Subject: CPV Vaca Station (08-AFC-11)
Response to CEC Staff Data Request 29, Cumulative Air Quality Impact Analysis

**Response to CEC Staff Data Request 29,
Cumulative Air Quality Impact Analysis**

CPV
Vaca Station

Response to CEC Staff Data Request #29

**Figure DR29-1
Cumulative Annual PM₁₀ Impacts**

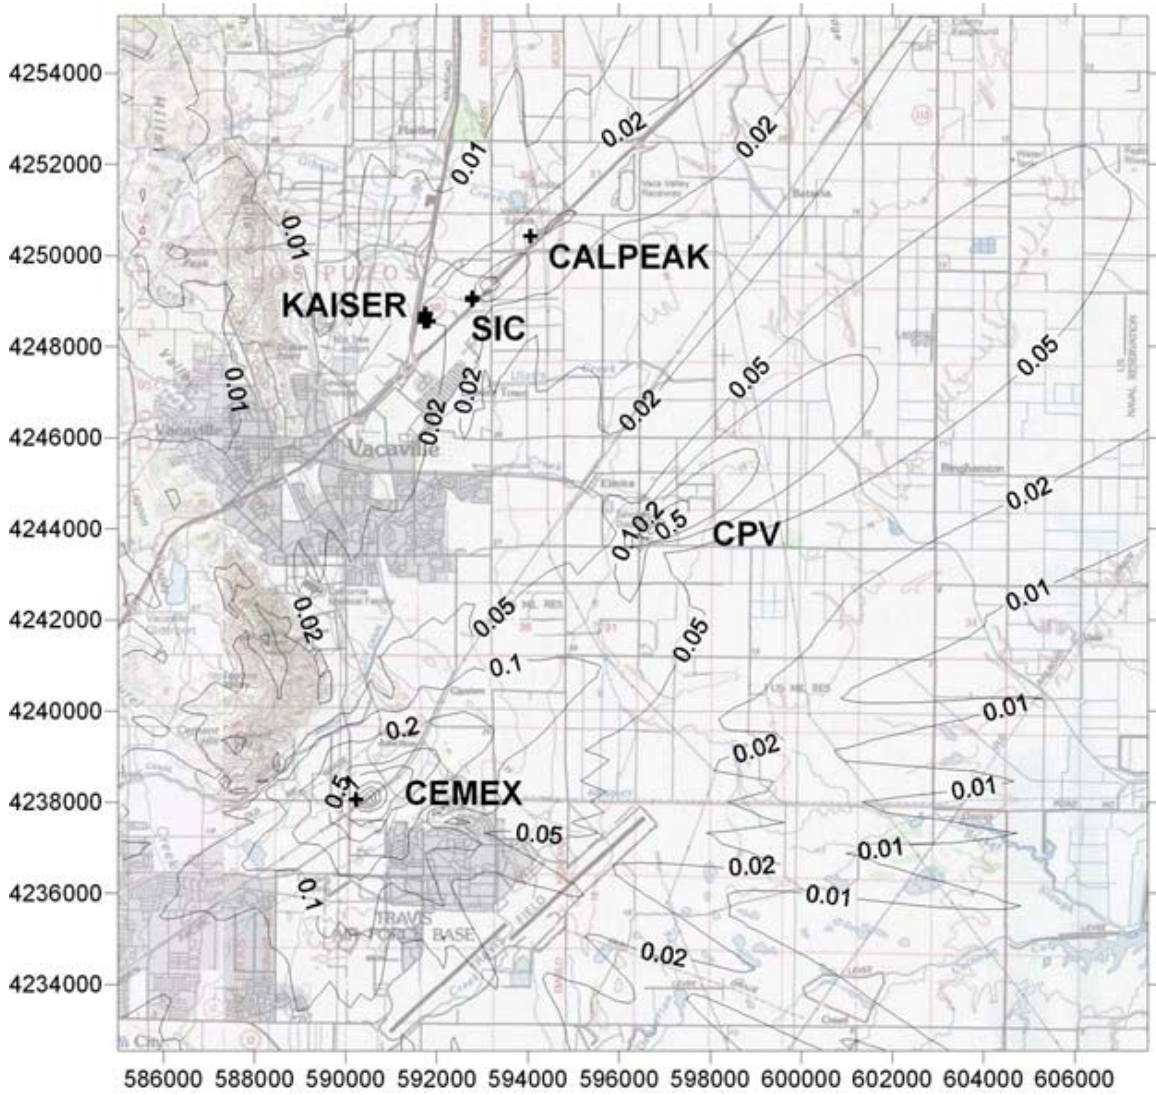
29. *Please provide the list of cumulative sources to be considered and the cumulative analysis for ambient air quality impacts.*

For example, Figure DR29-1 shows that the very high annual PM₁₀ concentrations attributable to CEMEX are very close in to the CEMEX source. CEMEX impacts at the CPVVS property site have fallen to approximately 0.05 ug/cu m (see also Table DR29-6). On the other hand, the impacts from CPVVS do not extend towards the CEMEX plant at all (see also Table DR29-7). Each of the facilities is outside of the area impacted by the other, so that there is, effectively, no cumulative impact from the projects. Figure DR29-3 shows that the same is true for cumulative annual PM_{2.5} impacts.
